Access Compliance Report

Public Rights-of-Way

Intersection ID: 42504	Main Street: ALEXANDER MARTIN AV	Cross Street: TOLLESON AV	Location: NW
ADA ID: D1E157EA166E	Ramp Type: PerpDiag	Initial Pass/Fail: Fail	Overall Compliance: No
Severity Score: 10			
Codes/Mitigation Info/Possible Solution		Field Measurements/Component Compliance

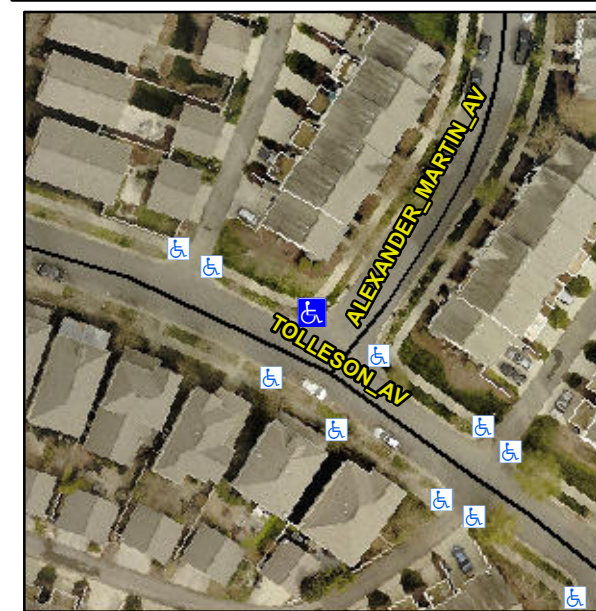
R304.5.1, R304.5.3

Compliance	Description	Data	Compliance	Description	Data
N/A	Ramp Length (in)	62.5	Yes	Ramp Slope (%)	7.1
No	Ramp Width (in)	39.0	No	Ramp XSlope (%)	2.2
N/A	Flare Type LT	N/A	N/A	Flare Type RT	N/A
N/A	Flare Slope LT (%)	N/A	N/A	Flare Slope RT (%)	N/A
N/A	Flare Traversable LT?	N/A	N/A	Flare Traversable RT?	N/A
N/A	Landing Length (in)	N/A	N/A	DWS Provided?	N/A
N/A	Landing Width (in)	N/A	N/A	DWS Contrast?	N/A
N/A	Landing Slope (%)	N/A	N/A	DWS Length (in)	N/A
N/A	Landing X Slope (%)	N/A	N/A	DWS Full Width?	N/A
N/A	Landing Curb? (Y/N)	N/A	N/A	DWS Offset (in)	N/A
N/A	Shared Landing?	N/A			
N/A	Gutter Ponding?	N/A	N/A	Gutter Slope (%)	N/A
N/A	Gutter Lip Ht (in)	N/A	N/A	Gutter X Slope (%)	N/A
N/A	Painted X Walk1?	No	N/A	Painted X Walk2?	No
	X Walk 1 Direction	To SW		X Walk 2 Direction	To SE
N/A	X Walk 1 Width (in)	N/A	N/A	X Walk 2 Width (in)	N/A
	X Walk 1 Slope (%)	1.1		X Walk 2 Slope (%)	3.3
	X Walk 1 X Slope (%)	1.4		X Walk 2 X Slope (%)	0.2

Remove & Replace Curb Ramp With Two New Directional Ramps or Equivalent.
